MCW Consultants Ltd.

Addendum

Project Name: AQUAVISTA - Bayside
Client: TRIDEL Corporation
To: TRIDEL Corporation
Attention: Chadi Loza
Fax number: -

Title: Various Electrical Changes.

E0-02

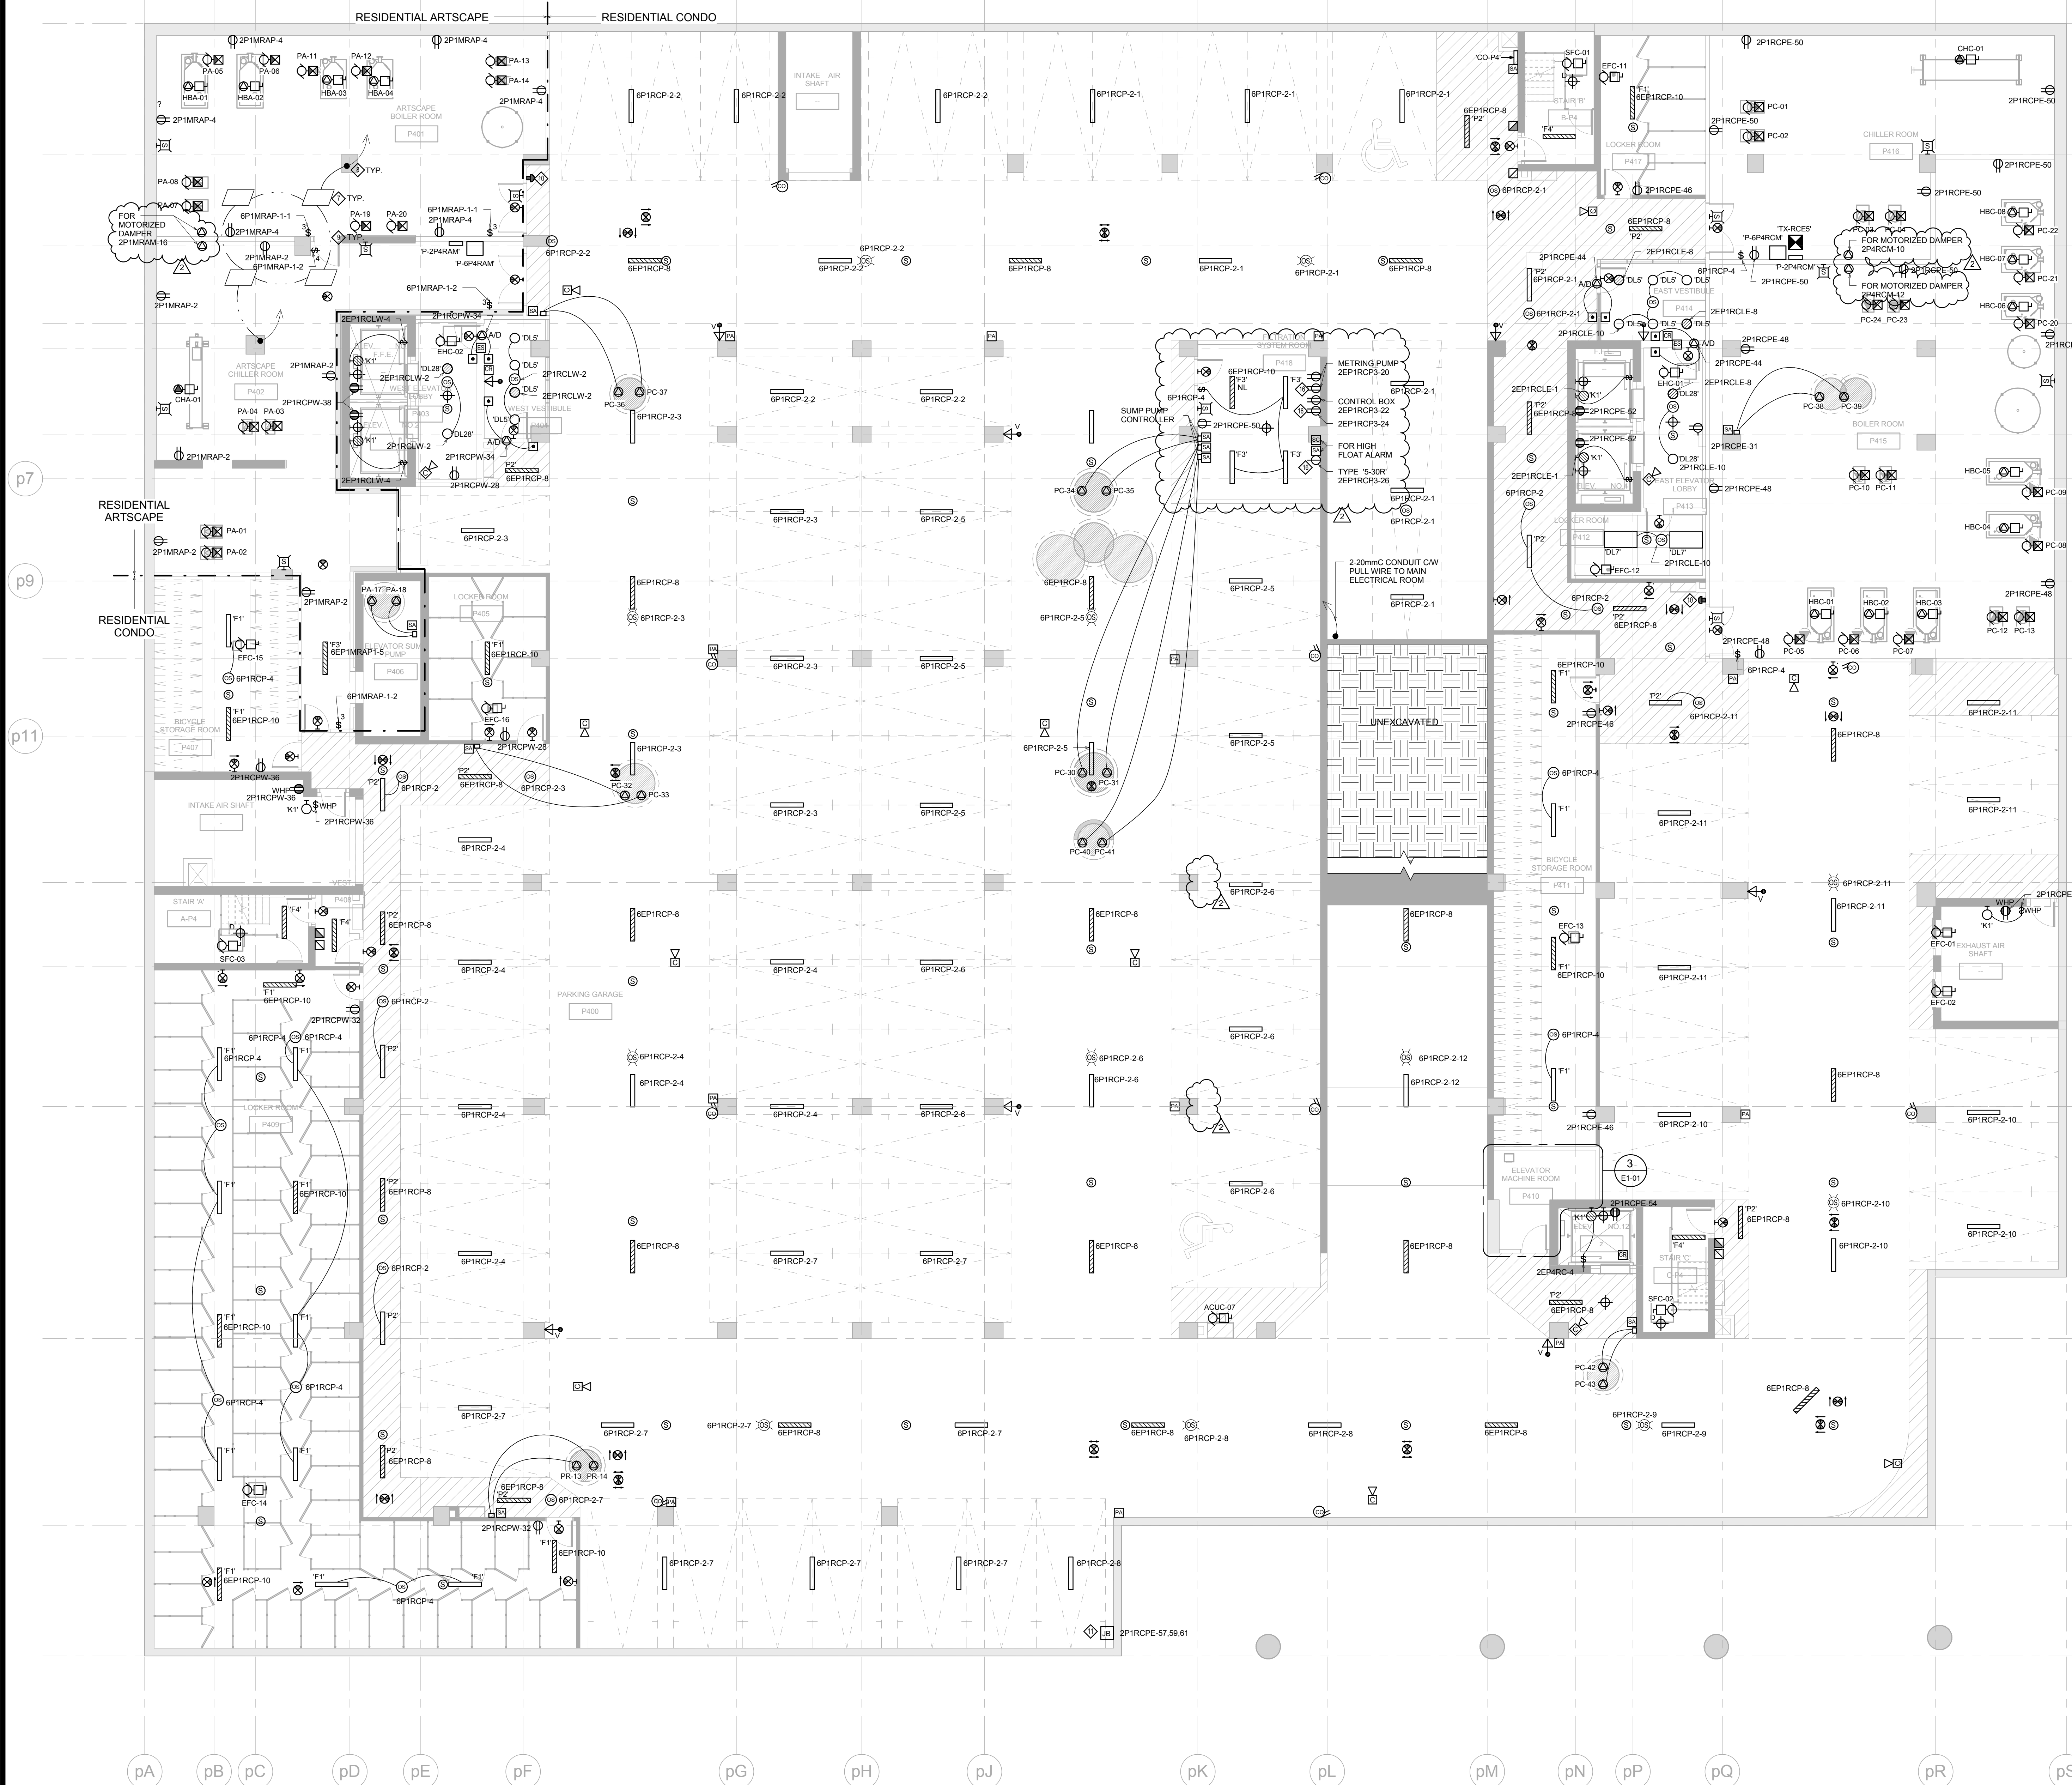
Drawing No.	Drawing Issued	Items
E0-01	Yes	- Legend has been updated for the security electric strike. - Add 'addressable module' & 'supervisor contact' symbols as shown.
E0-02	Yes	Communication room layouts have been updated as shown.

As Indicated
Author
Checked By
Checker
S489D
Date
08/28/12
Drawing No.
E1-01

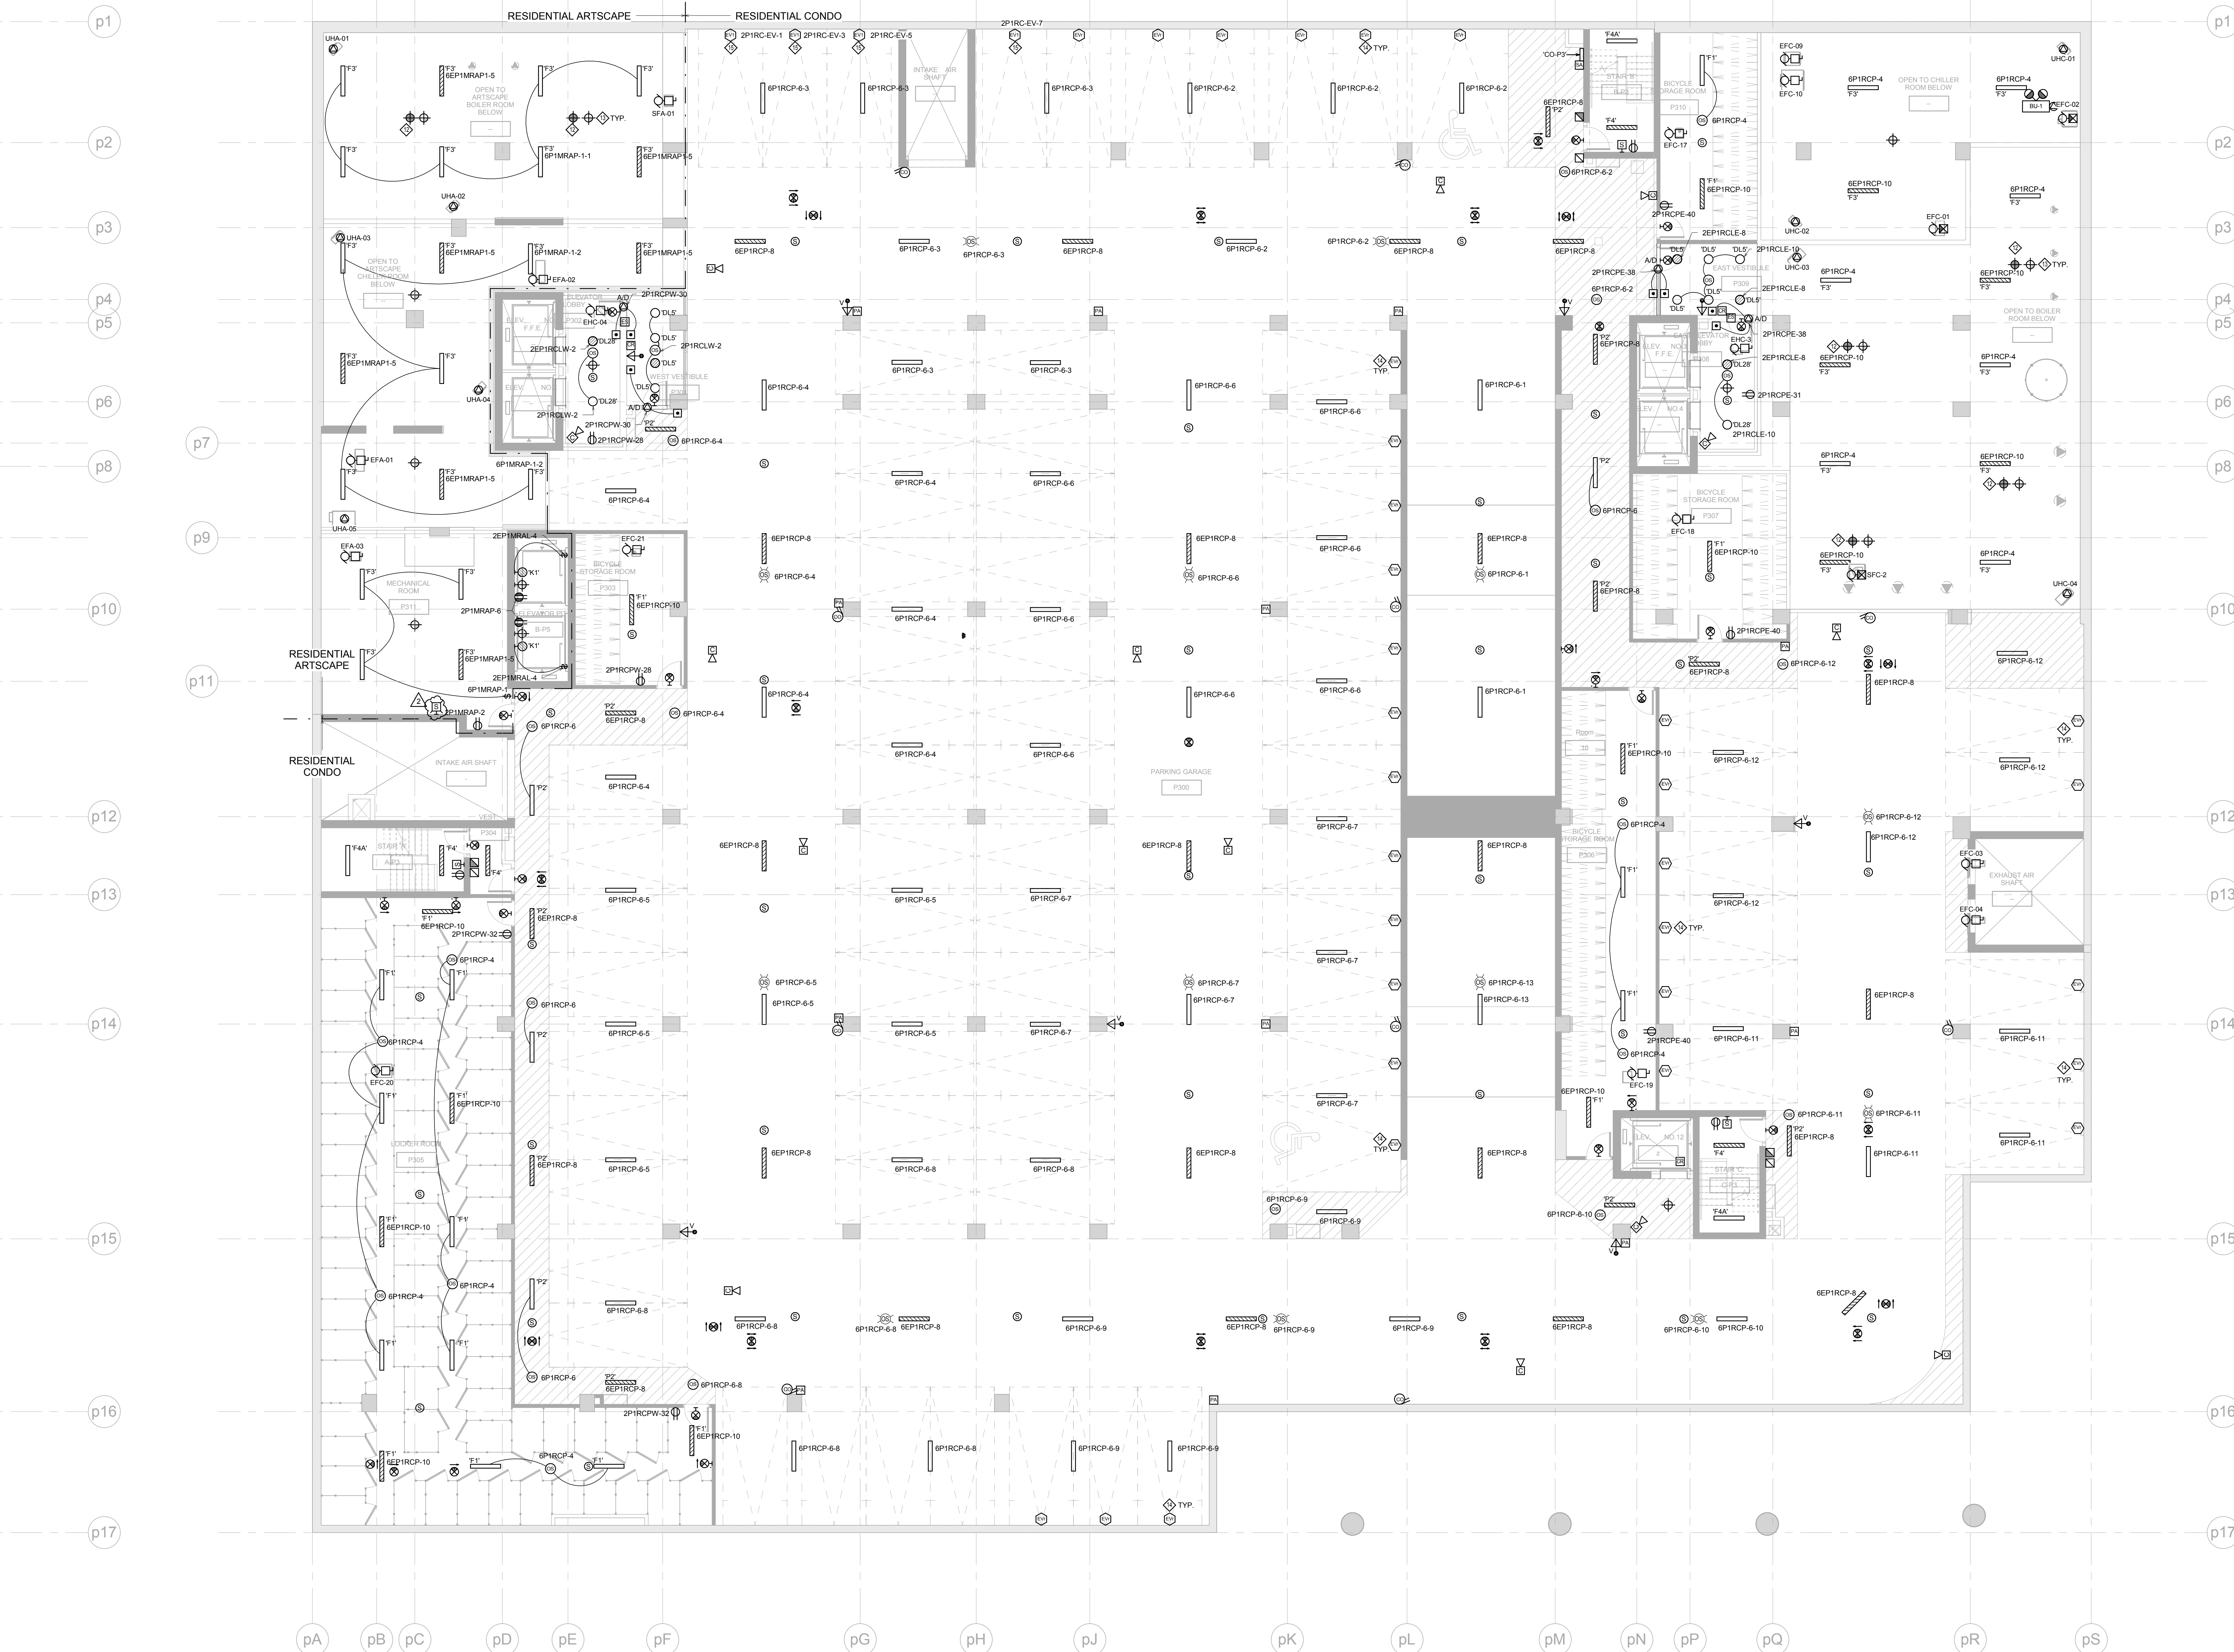
E1-01	Yes	- Add electrical devices to Filtration System Room (P418) as shown. - Relocate sump pump controllers on P4 level as shown. - Add power connections for motorized damper in mechanical room on P4 level as shown. - Add fire alarm speaker/strobe in Mechanical Room (P311) on P3 level as shown.
E1-02	Yes	- Revise and add electrical devices to match architectural layout in CCU room area on P2 level as shown. - Revise electrical devices on retail shower area to match architectural layout on P1 level as shown. - Add power connections for AC units on P1 level as shown.
E2-01A	Yes	Revise security devices on stair exterior doors as shown.
E2-01B	Yes	- Add remote fire alarm annunciator in commercial elevator lobby as shown. - Revise security devices on stair exterior doors as shown.
E2-14A	Yes	- Revise lighting fixture type in Storage Room (1316) as shown. - Add power connections for motorized damper in mechanical rooms as shown. - Communication room layout has been updated as shown.
